INDIAN POINT NUCLEAR GENERATING UNIT NO. 2

Amendment No. 52  
License No. DPR-26

ATTACHMENT TO LICENSE AMENDMENT NO. 52

SUPPORTING AMENDMENT NO. 52 TO FACILITY OPERATING LICENSE NO. DPR-26

Figure 3.10-2

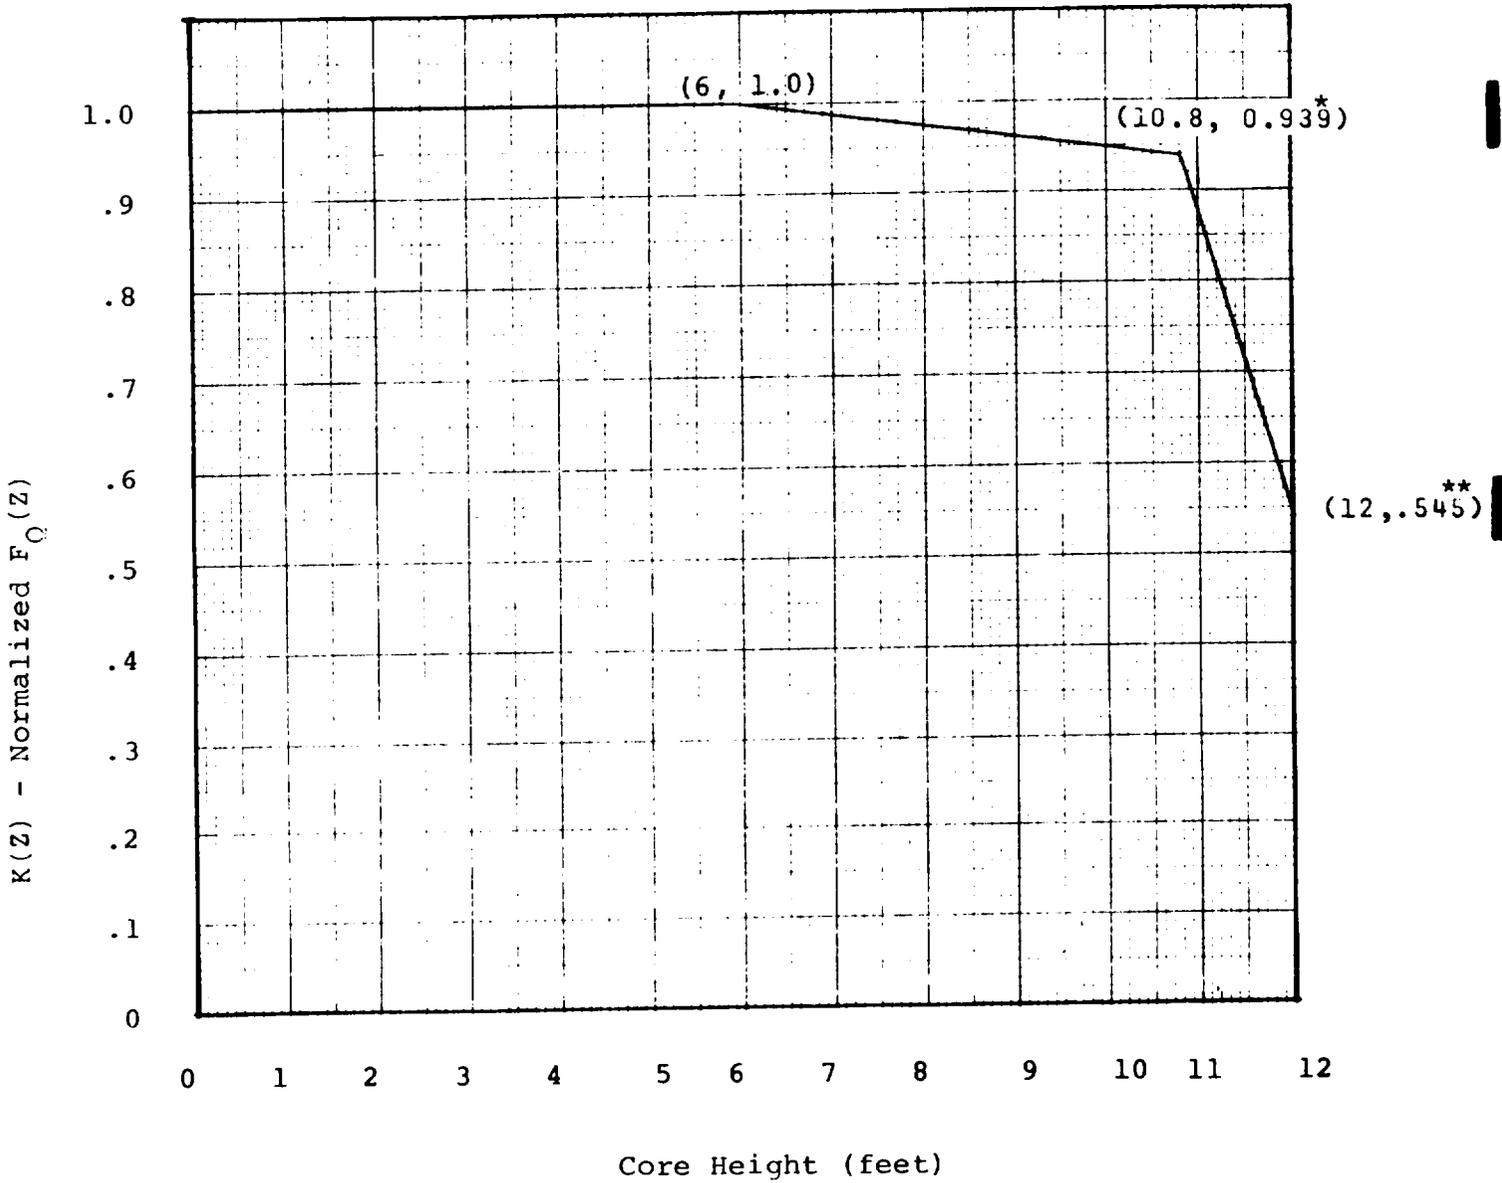
The technical specifications on power distribution control assure that  $F_Q$  upper bound envelope of 2.31 times Figure 3.10-2 is not exceeded and xenon distributions are not developed which at a later time, would cause greater local power peaking even though the flux difference is then within the limits specified by the procedure.

- (1) Total peaking factor, FQ, shall not exceed a maximum limit of FQ=2.31,
- (2) Accumulator water volume shall be reduced to 716 cu ft, minimum and 731 cu ft maximum, and
- (3) The hot channel factor normalized operating envelope shall be modified.

\*Pending return to operation for Cycle 4 this value shall be 0.94.  
\*\*Pending return to operation for Cycle 4 this value shall be .54.
